Northparkes Step Change Project: MP11_0060

As foreshadowed in the preliminary environmental assessment, as further studies concerning the project have progressed, we now write to amend the project application and seek a modification of the DGRs to reflect the amended application.

FIGURE 2

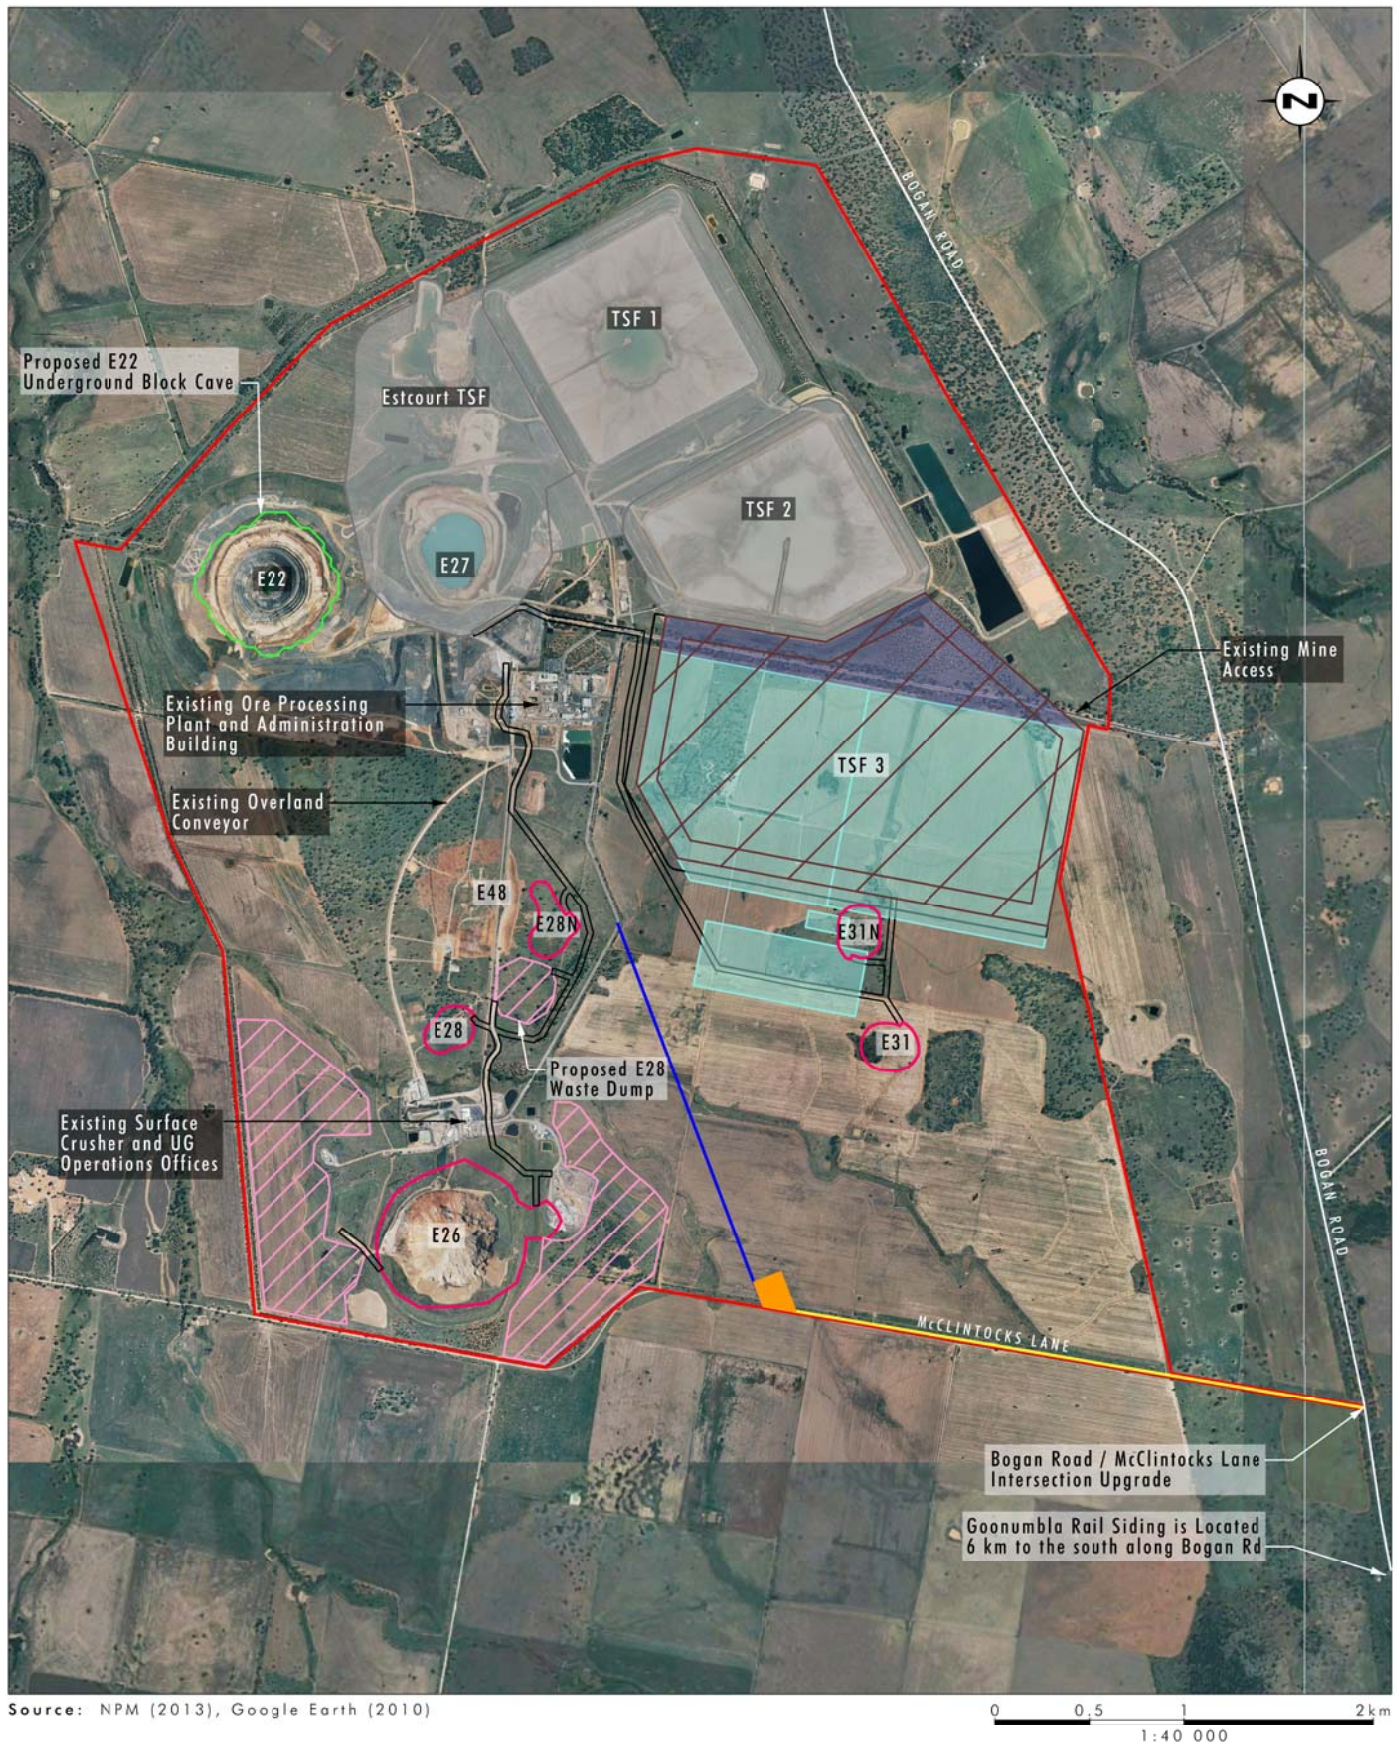
- (a) Continued operations under the E48 project approval MP06_0026 (as modified);
- (b) Development of underground block caving in the E22 resource;
- (c) Campaign open cut mining through development of five open cut resources (E31, E31N, E28, E28NE and E26) including:
 - (i) Development of four small open cut pits E31, E31N, E28, E28NE (approximate surface areas of 6ha and depths of 60-80 metres); and
 - (ii) Proposed E26 open cut (approximate surface area of 50ha and depth 300 metres) which is located in an area of previous underground block cave subsidence (existing vertical extent of subsidence void is approximately 200 metres);
- (d) Amendments to the configuration of tailings storage facilities (TSFs) (refer to Figure 1);

- (e) Development of new dumps for the management of E28/E28NE and E26 open cut waste rock. (Waste rock from open cut mining areas (particularly E31 and E31N) will be utilised in the development of TSF 3); and
- (f) The extension of mine life by an additional 7 years.
